SUNDRY NOTICES AND REPORTS ON WELLS

2. Name of Operator
Tandem Energy Corporation

8. Well Name and No.
Southern Union 2-Y

9. API Well No.
30-015-20248

Tandem Energy Corporation
SOUTHERN UNION 002Y
HACKBERRY

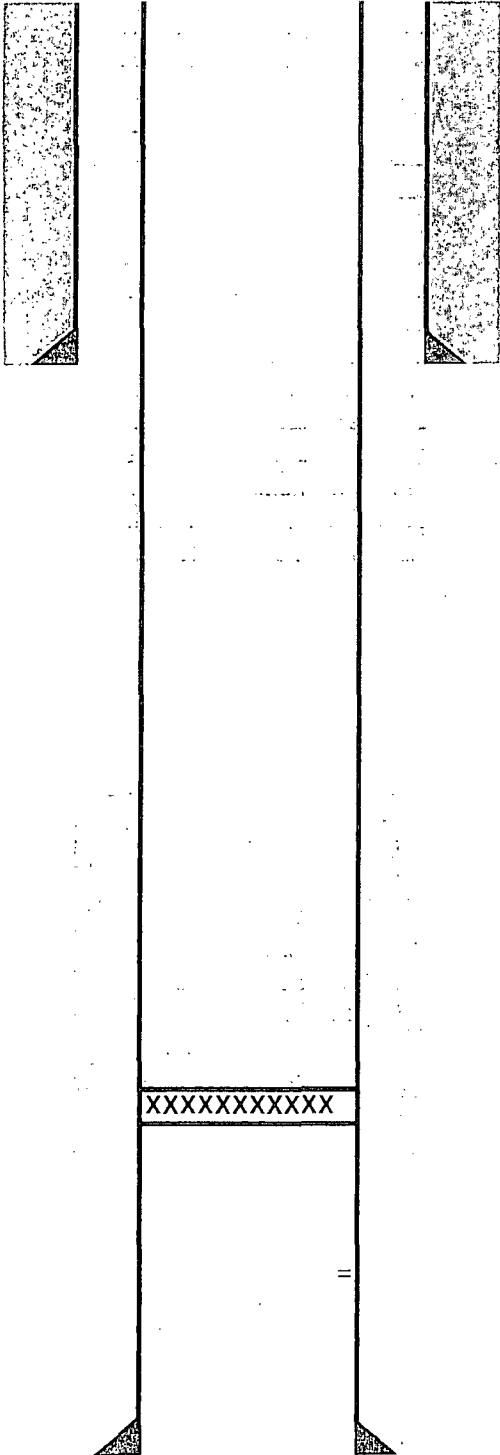
- 1.) Circulate hole with mud laden fluid
- 2.) ~~Set east iron bridge plug at 1850'~~
- 3.) ~~Set cement plug from 1850' to 1723' (16 sacks)~~
- 3.) ~~Tag plug at 1723'~~
- 4.) Perf casing 50' below top of salt at 630'.
- 5.) Circulate cement to surface. (100 sacks)
- 6.) Tag plug inside casing at 425'.
- 7.) Set cement plug 60' to surface. (8 sacks)
- 8.) Install dry hole marker.
- 9.) Use steel tanks for pit and haul fluids off for proper disposal.

*Spot cement plug over perfs and B/salt 2135'-1817'.
WOC Tag*
